Design Officer	Azhar Kapadi
Date	14.03.25 29.04.25 Set 2 Comments
Application Reference	24/01262/FUL
Address	Village Hotel Bury, Waterfold Business Park, Rochdale Rd, Bury BL9 7BQ
Proposal	Erection of a 34-bedroom extension to existing hotel and associated works

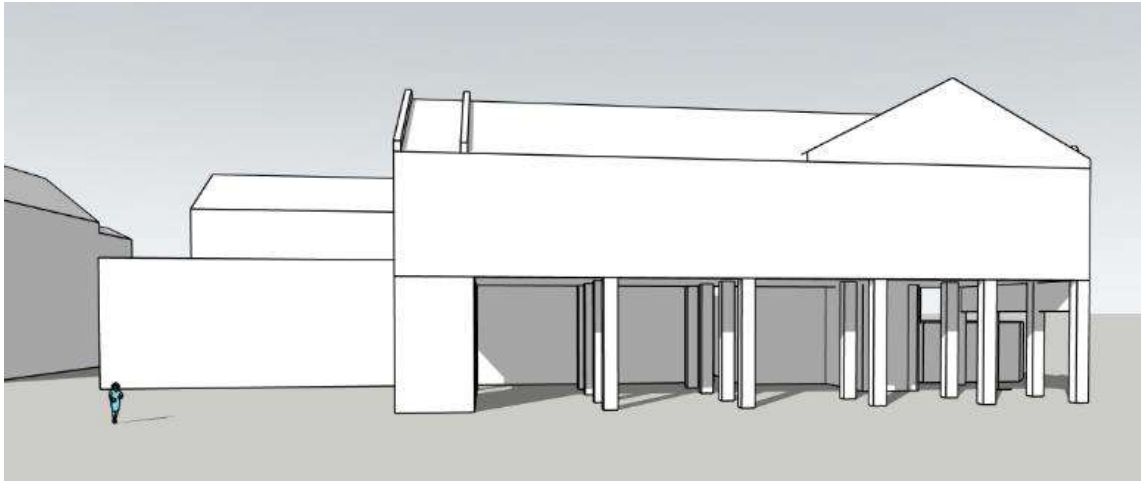
The building footprint has increased with the capacity increasing from 27 beds to 34. The design and massing of the extension has however been poorly compromised in order to accommodate this. It was considered at that time, monotonous elevations needed to be improved and the building footprint should move inwards from the site boundary and maintain the tree/ landscaped buffer to the neighbouring site. The design statement has highlighted design related comments I made but very little has been done to address them.

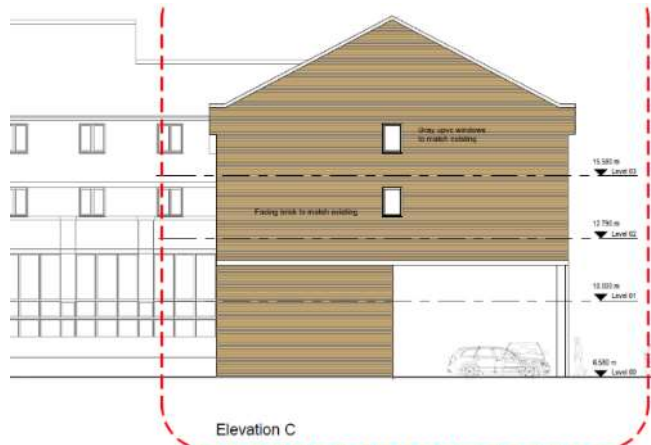
Elevation B is overly dominating, characterised by unsightly large columns that are no longer screened

Due to a lack of articulation and detail, the elevations look something more reminiscent of poor student housing scheme or a prison building. Refer back to preapp comments on how to improve this.
